PD Modification Application: PRS 26-0617

Hillsborough
County Florida

Development Services Department

The applicant is requesting a minor modification to add an optional stub out point to the southern boundary, which could allow a connection to Bishop Road. No changes to the entitlements are proposed.

8.2 Proposed Site Plan (Full)

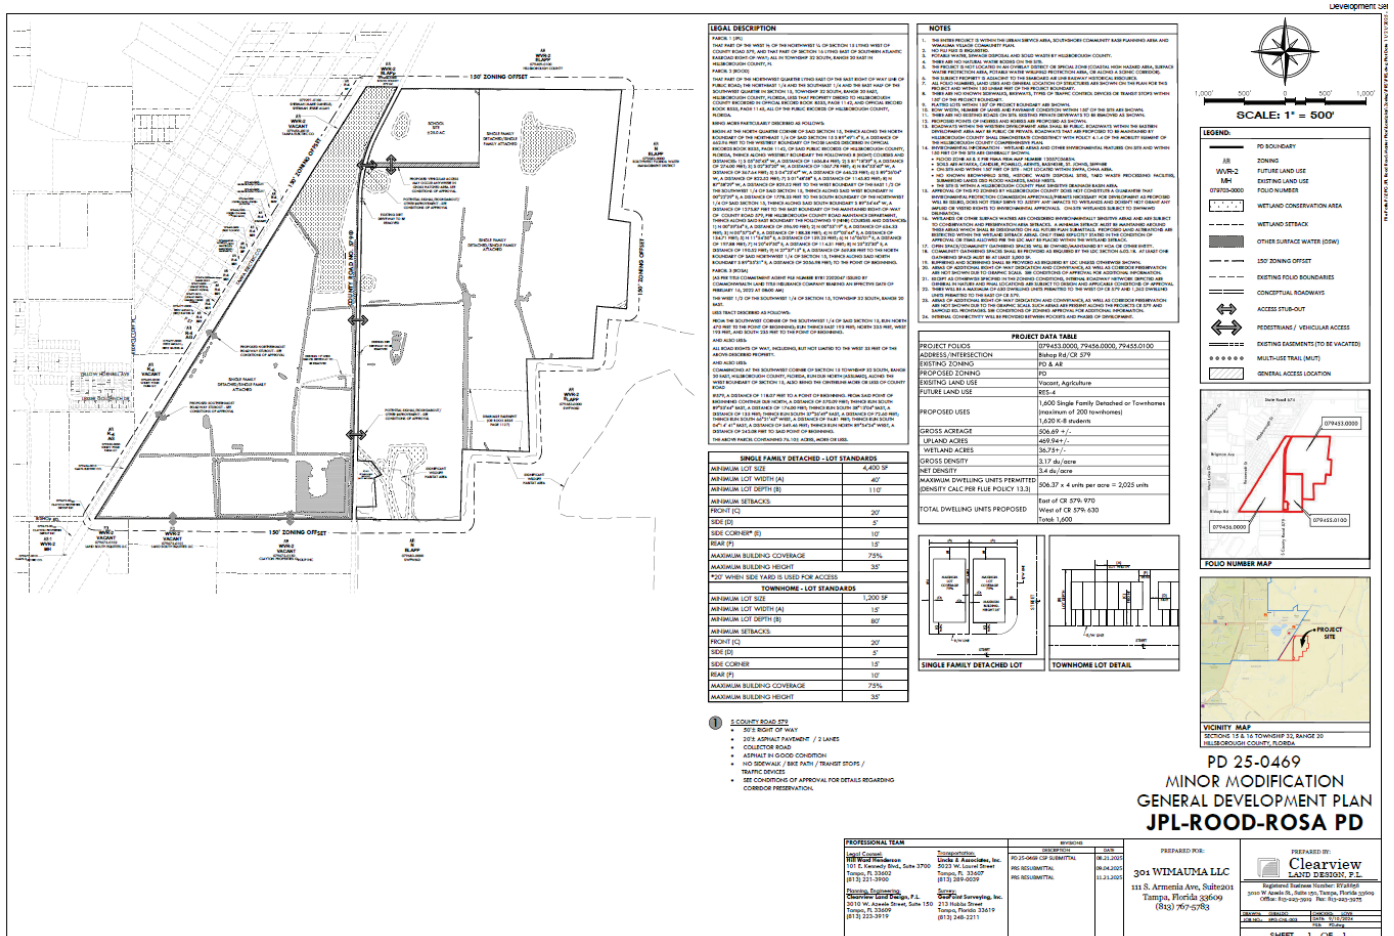
Staff does not have any compatibility concerns with the requested modification to add an optional access/stub out to the southern boundary.

1. Add labels at the proposed (middle) project intersection on CR 579 and label as “Potential Signal/Roundabout/Other Improvement – See Condition of Approval”.

--Southern Boundary--

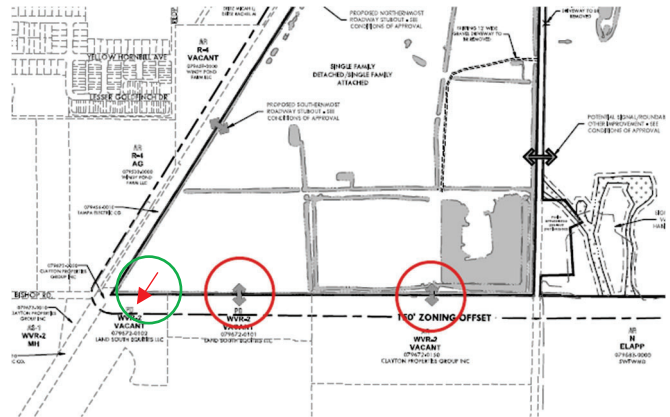
The southern property boundary is approximately 3,200 feet in length (between the TECO corridor and CR 579). Given the connection spacing standards, a total of two connections would be required (rounded down from 2.42).

The developer is providing two connections, in addition to the CR 579 north-south corridor, (for a total of three connections provided). Applicant-proposed through road connections are shown circled in red. An additional optional stubout along the southern boundary is being proposed as a part of this PRS (as further described herein above) which, if constructed, would result in a fourth connection.

--Overall Analysis and Connectivity--

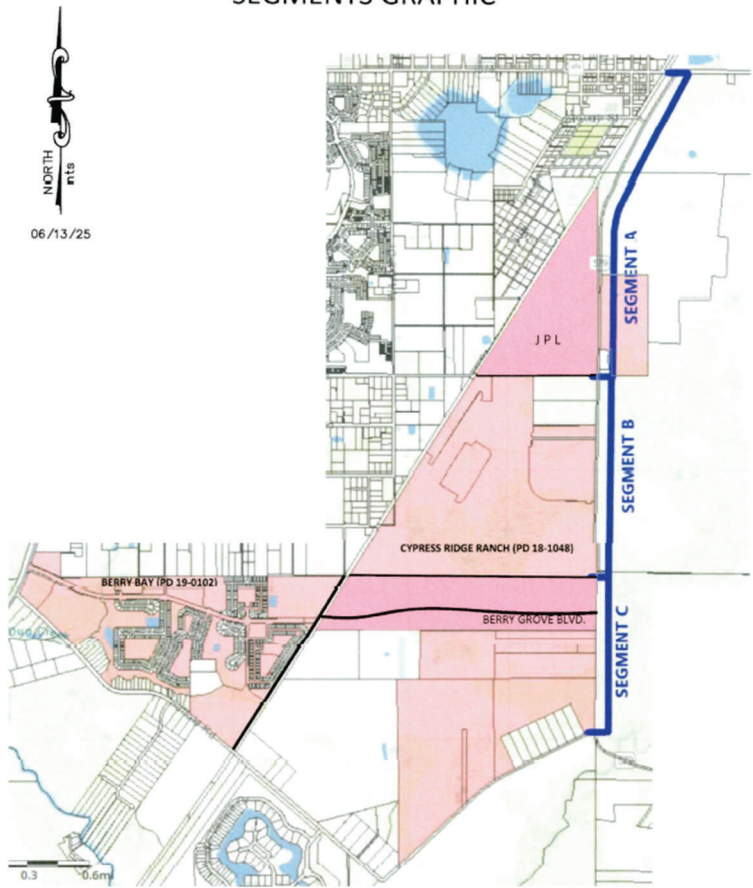
Where the term “through road” is used, it should be noted that this term is used loosely to denote any roadway connection or stubout (whether or not there is a roadway currently planned to connect to the stubout). This offset roadway design also has the effect of calming through road traffic, and is consistent with LDC Section 6.02.01.A.10 which states “Local streets should be designed to discourage excessive speeds. Residential streets should be designed to discourage fast movement (more than 30 MPH), through the use of curvilinear alignment and by offsetting local street intersections.” Internal project design will be reviewed for compliance with this and other applicable standards at the time of site/construction plan review. Notwithstanding the above, staff has prepared a graphic showing approved projects, planned and under construction corridors, together with other possible corridors to conceptually demonstrate how connectivity is planned and can potentially be enhanced to meet community goals. Staff notes that such connectivity not only increases bicycle and pedestrian safety and provides alternate routes to schools and for emergency vehicles, but it also provides important redundancy in our roadway systems, which can become critical alternative routes during accidents, other emergencies, and to maintain the safe/functional operations of our roadways and intersections as area roadways exceed planned capacities.

--Southern Boundary--

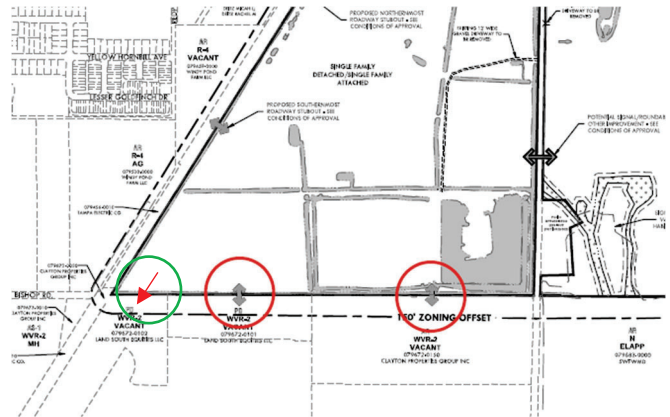
The southern property boundary is approximately 3,200 feet in length (between the TECO corridor and CR 579). Given the connection spacing standards, a total of two connections would be required (rounded down from 2.42).

The developer is providing two connections, in addition to the CR 579 north-south corridor, (for a total of three connections provided). Applicant-proposed through road connections are shown circled in red. An additional optional stubout along the southern boundary is being proposed as a part of this PRS (as further described herein above) which, if constructed, would result in a fourth connection.

--Overall Analysis and Connectivity--

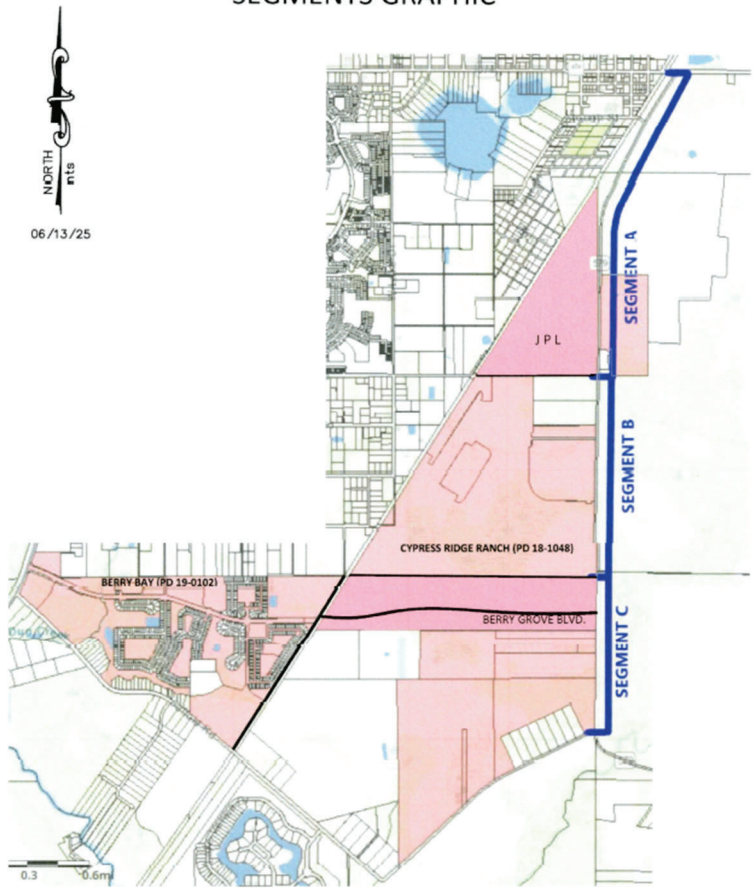
Where the term “through road” is used, it should be noted that this term is used loosely to denote any roadway connection or stubout (whether or not there is a roadway currently planned to connect to the stubout). This offset roadway design also has the effect of calming through road traffic, and is consistent with LDC Section 6.02.01.A.10 which states “Local streets should be designed to discourage excessive speeds. Residential streets should be designed to discourage fast movement (more than 30 MPH), through the use of curvilinear alignment and by offsetting local street intersections.” Internal project design will be reviewed for compliance with this and other applicable standards at the time of site/construction plan review. Notwithstanding the above, staff has prepared a graphic showing approved projects, planned and under construction corridors, together with other possible corridors to conceptually demonstrate how connectivity is planned and can potentially be enhanced to meet community goals. Staff notes that such connectivity not only increases bicycle and pedestrian safety and provides alternate routes to schools and for emergency vehicles, but it also provides important redundancy in our roadway systems, which can become critical alternative routes during accidents, other emergencies, and to maintain the safe/functional operations of our roadways and intersections as area roadways exceed planned capacities.
